SUBJECT: Class II Permissive change

This is to request a Class II permissive change as following FCC ID.

FCC ID: MMAT75A

Saw filter change to LC filter

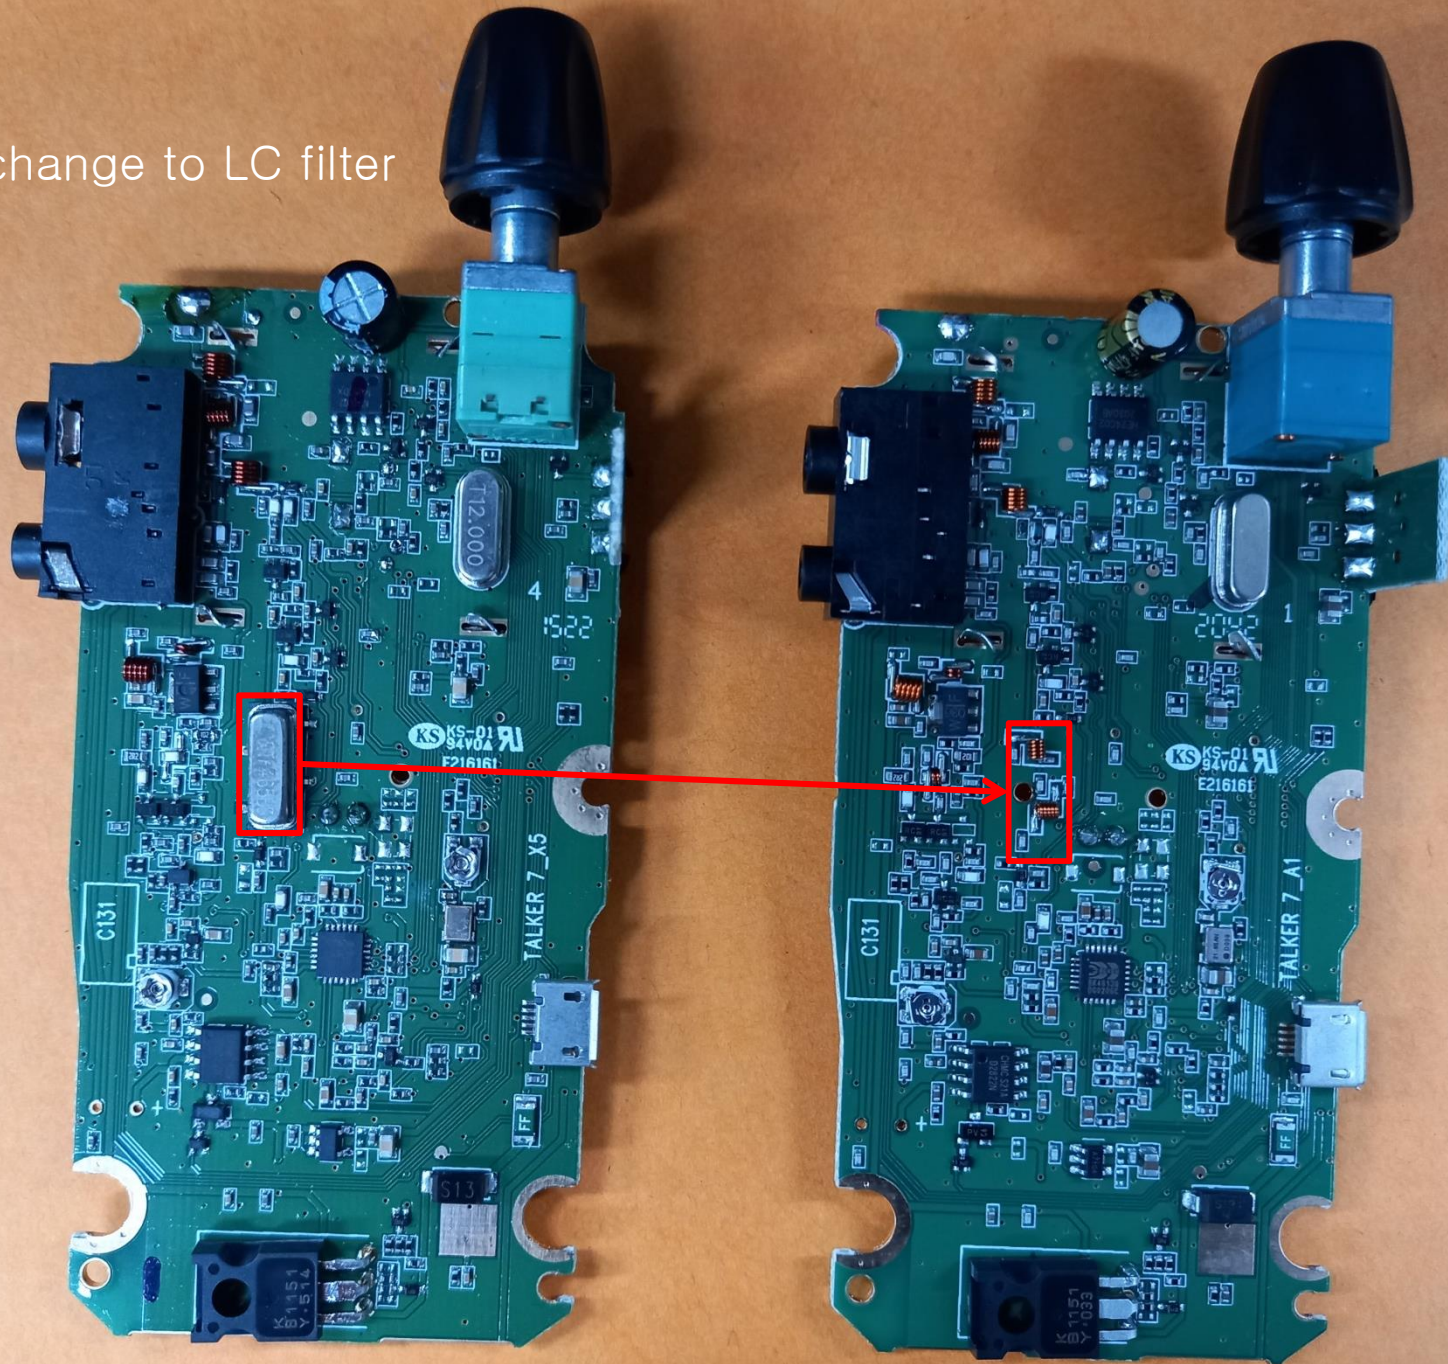
- 1) SF1(FTF465BS) of Saw filter change to Y18 LC filter(C71, C72, C75, C78, L16, L19)
- 2) IC6(GT809118) of Animal tone IC change to NY4B018C
